**GENERAL
CORRESPONDENCE**

From: Griswold, Jim, EMNRD
Sent: Wednesday, October 20, 2010 8:43 AM
To: 'bgrimes@btaoil.com'
Cc: 'mark@laenvironmental.com'; VonGonten, Glenn, EMNRD; Bonham, Sherry, EMNRD; Macquesten, Gail, EMNRD
Subject: BTA Pardue "C" 8808 JV-P Well #1 facility cleanup

**Re: Case No. 14413 - Exemption to Remove Plugged Well Monument
BTA Oil Producers LLC, Pardue "C" 8808 JV-P Well #1, API No. 30-015-26341
Latitude 32° 18' 46.77896 North, Longitude 104° 03' 41.94813 West
Unit N (SE/4, SW/4), Section 11, Township 23 South, Range 28 East NMPM
Eddy County, New Mexico**

Figure - Proposed Wells For Plugging

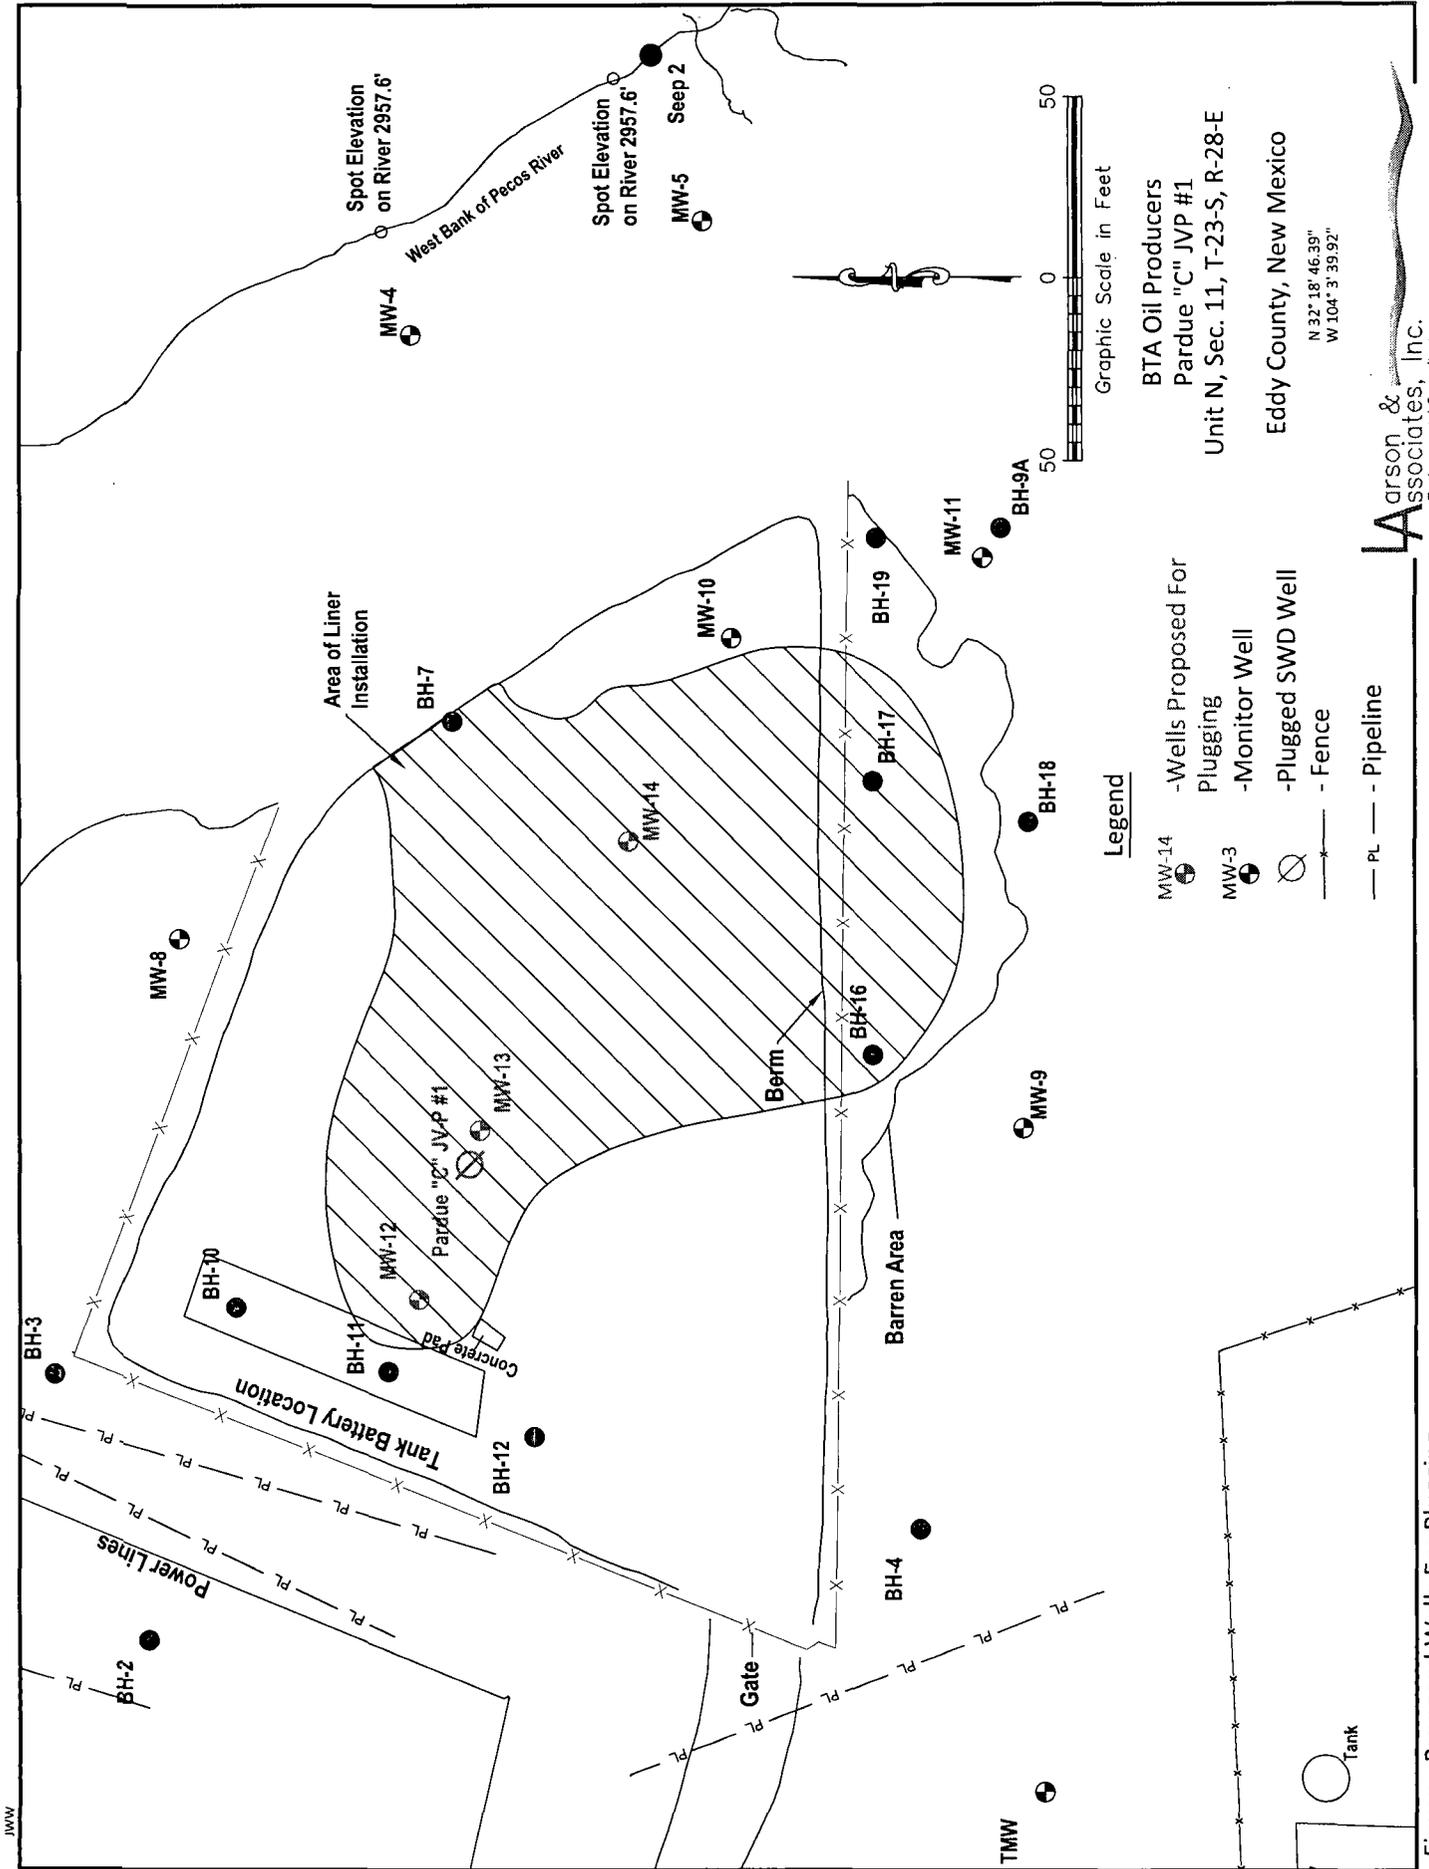
This message is submitted to the New Mexico Oil Conservation Division (OCD) on behalf of BTA Oil Producers LLC (BTA) by Larson & Associates, Inc. (LAI), its consultant, to update the OCD on the progress of soil remediation activities and request approval to plug three (3) monitoring wells (MW-12, MW-13 and MW-14) and a variance to remove the monument from the plugged well (Pardue "C" 8808 JV-P Well #1) to eliminate protrusions through the bentonite and polyethylene liner and pathways for water to infiltrate beneath the liner which will be installed in the bottom of the excavation at about 5 feet bgs. The monitoring wells will be plugged by cutting the PVC casing at a depth below the liner and plugging the wells with bentonite chips. The plugged monument will be removed, casing cut off and welding a steel plate over the casing at a sufficient depth below the liner. The attached drawing shows the liner installation area, wells to be plugged and plugged Pardue "C" 8808 JV-P Well #1.

I have reviewed the requests to plug groundwater monitoring wells MW-12, -13, and -14 along with removing the well monument on the plugged SWD well as part of the soil reclamation efforts at the facility. Both these requests are approved under the condition that those efforts be completed as described. A properly completed and signed C-103 sundry notice should be filed both with myself and the District II office in Artesia for the disposal well once work has been completed. Please keep a copy of this email for your files as no written approval will be sent. Thank you.
